From: Borski, Jennifer - DNR
Sent: Wednesday, October 23, 2019 11:53 AM
To: Brian Wayner
Cc: 'kyle.weeks@omni.com'; 'bob.givens@omni.com'
Subject: FW: Miller Electric Melvin St. Parking Lot Proposed Soil Boring Map
Attachments: Proposed Soil Boring Map Melvin Street Parking Lot.pdf; Mauthe_FS_Cr_Soil_Maps.pdf; Mauthe_FS_Soil-GW_Map.pdf; Mauthe_FS_Cover.pdf

Proposed Soil Borings

Subject: Final Feasibility Study Report
N.W. Mauthe Site, Appleton, Wisconsin

FIGURE 2-3 (Sheet 1 of 2)
Total Chromium Concentrations in Soil
 N.W. Mauthe Site FS Report

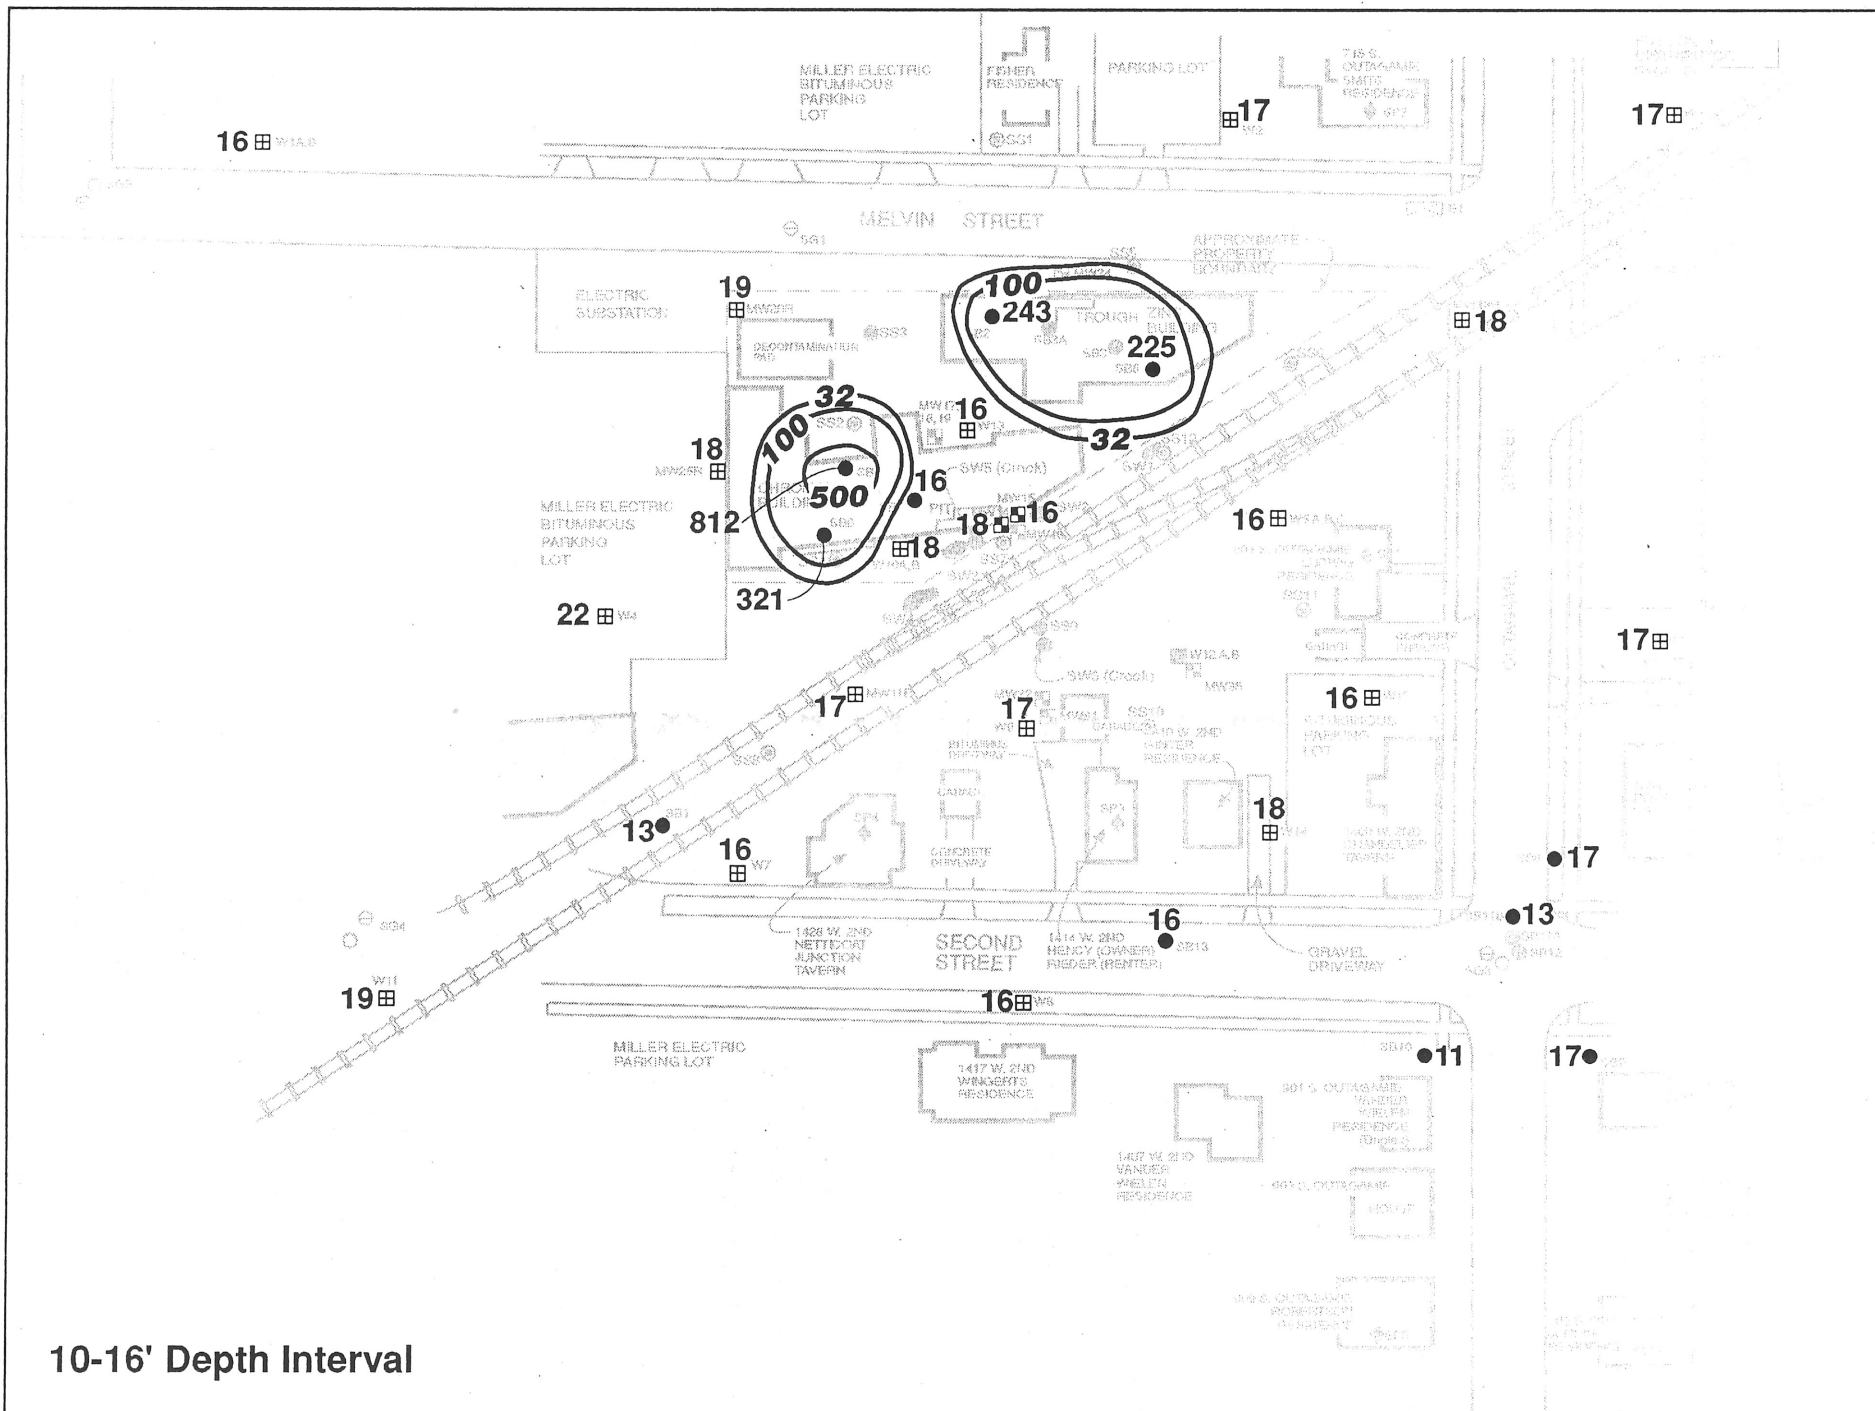
Parking lot replacement that includes removal of the asphalt, sub-base and possibly soil will require further coordination. Please see the attached maps scanned from the May 1993 Feasibility Report that may be of interest. As you are aware, finite delineation of the chromium contamination was not performed by USEPA and documentation of investigation/remedial work performed is also lacking. However, the attached maps provide some insight into possible residual chromium in shallow soil beneath the Miller parking lot.
